**SCOTT COUNTY
ZONING BOARD OF ADJUSTMENT
AGENDA**

Scott County
Zoning Board of Adjustment
STAFF REPORT
August 26, 2026

Request: A variance for a reduced front yard setback to allow construction of an addition to an existing single-family dwelling

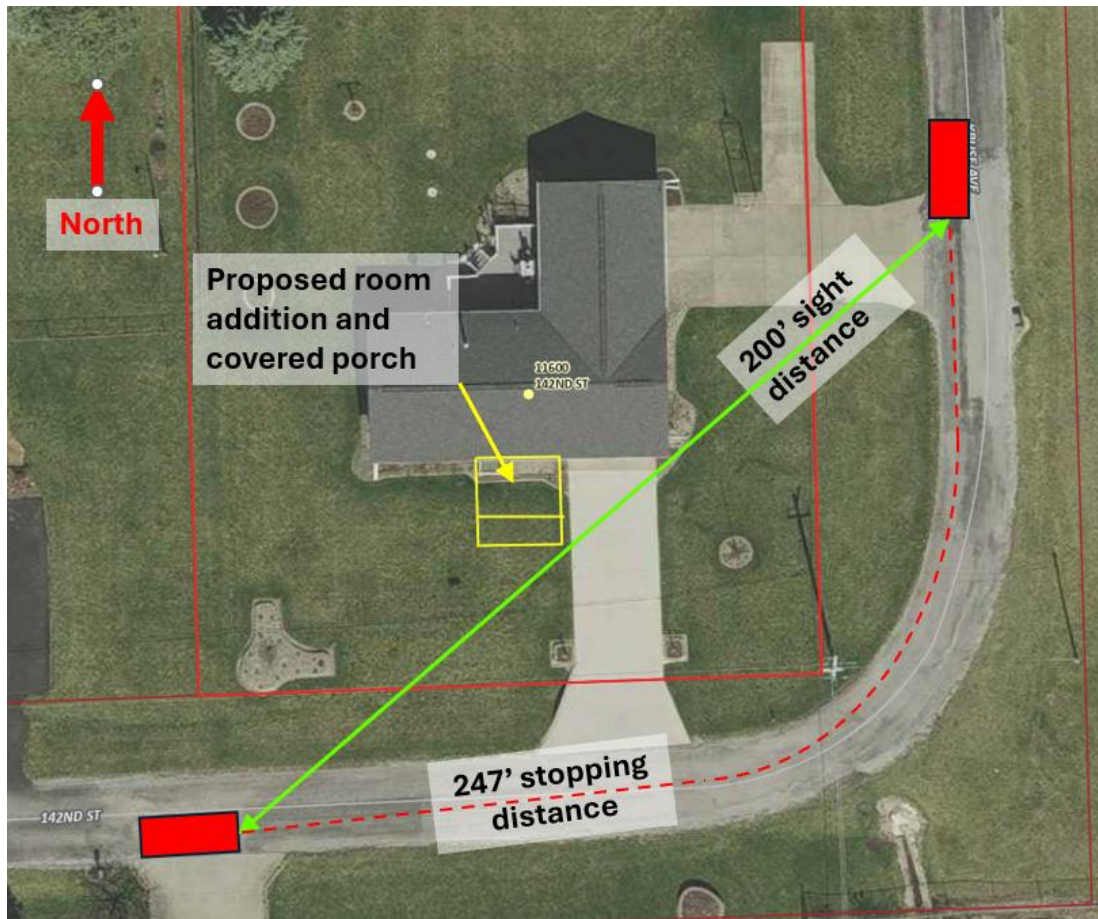
The subject dwelling sits approximately 50' from the south property line and 30' from the east property line. Because the east side of the dwelling has a smaller front yard setback than currently required, County Zoning regulations classify it as a 'nonconforming structure.' Nonconforming residential structures are allowed to remain in place unless or until they are destroyed by any means to an extent that more than fifty percent of their assessed value is lost. Additionally, nonconforming residential structures are allowed to be extended or enlarged as long as the work does not result in an increase in the nonconformity. Thus, if the desired addition were located on the north side of the existing dwelling, and did not reduce the existing 30' setback, it would be allowed with no need for a variance. It is not stated whether a structure on a corner lot, which already encroaches in one front yard setback, is allowed to encroach in the other front yard setback to the same extent.

Additionally, County Zoning regulations allow larger or smaller front yard setbacks if 50% or more of lots with frontage on the same side of the observe a greater or lesser setback than currently required. In such cases, the front yard setback of a subject property is determined by averaging the setbacks of the structures on either side of the subject property. This regulation does not address corner lots, where there is only one adjacent structure along a particular frontage. As shown on the previous image, two of the three structures with southerly frontages along 142nd Street encroach in the required front yard, but without a dwelling east of the subject property it becomes impossible to determine the allowable setback. If we were to interpret the regulation to wrap around the corner, and thus the allowable setback would be the average of the setback for the existing structures to the west and north of the subject property, the allowable setback would be 42', and thus a variance would still need to be requested. However if the regulation is interpreted to extend around the corner, essentially ignoring that corner and double-frontage and instead treating the subject property as if it were in the middle of a straight line of lots, the subject property would arguably be allowed to construct the requested addition without need for variance because it already observes a 30' front yard setback.

Lastly, the subject property measure 130' by 231', or 30,030 square feet. Had it been platted such that it was smaller than 30,000 square feet, it would qualify for 'small lot status' per County Zoning regulations, resulting in a reduced front yard setback of 25'.

Regarding the proposed covered porch that would extend an additional 5'10" into the front yard, County Zoning regulations allow such porches to encroach up to 20% into front yard setbacks. Thus if a 38' front yard setback is approved by variance, the porch would be allowed to encroach 7'7" into the front yard.

Regarding the criteria for approval of variances, it is staff's opinion that the applicant has demonstrated the practical difficulties faced are unique to the property at issue and not self-created. Had the past property owner known that future regulations would limit possible expansions, the dwelling layout and/or location could have been planned in a manner to better accommodate expansion. As it stands for the subject property, westerly expansion is not practical as the proposed living room would sever the existing bedrooms. Northerly expansion would result in the proposed living room being separated from the other living space by the garages. And a northwesterly expansion would impact an existing deck, air conditioning compressor, and potentially the septic tank.

RECOMMENDATION: Staff recommends **approval** of the variance to allow a reduced front yard setback of 38 feet for a southerly addition to the existing single-family dwelling. The recommendation is based on the practical difficulties faced being unique to the property at issue and not self-created, and the variance not significantly altering the essential character of the surrounding neighborhood.

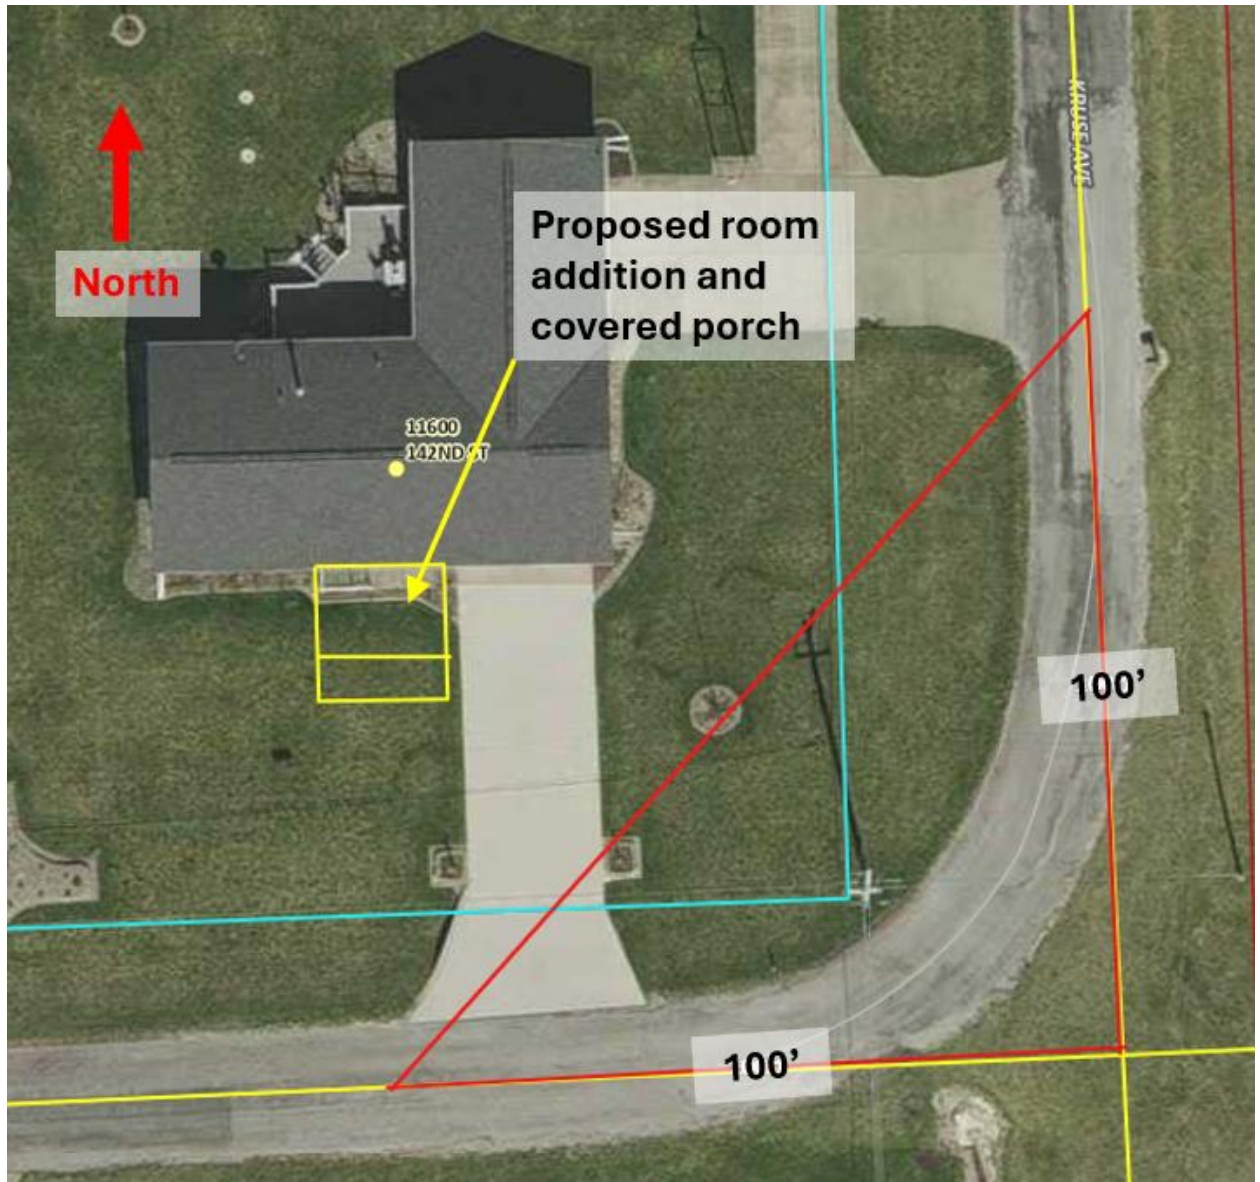
Regarding the implications of the proposed addition, with the dwelling situated at a curve in the road consideration should be given to whether the proposed addition would impact sight distances for nearby drivers. Neither 142nd Street nor Kruse Avenue are County-owned roads, and no road design drawings were found in County Planning & Development Department records. Current County road design requirements suggest a 25 mph road should have a curve radius of at least 198', and generally-accepted design guidance suggests an absolute minimum of 134'. The existing radius of the inside lane is approximately 58', thus the design speed limit of the curve can be assumed to have been lower than 25 mph. Despite that presumed lower speed limit, for purposes of this exercise we assume a 25 mph design speed limit.

On 25 mph roads, the County's required 'stopping sight distance,' which is the distance needed to observe an obstruction and safely bring a vehicle to a stop, is 155'. As shown in the following image, the proposed addition would result in a sight distance of approximately 200', and a stopping distance of nearly 250'.

County Zoning regulations also require a 100' x 100' 'sight triangle' at roadway curves and intersections, which is illustrated in the below image.

As both criteria are satisfied, the proposed addition is not expected to obstruct necessary sight lines.
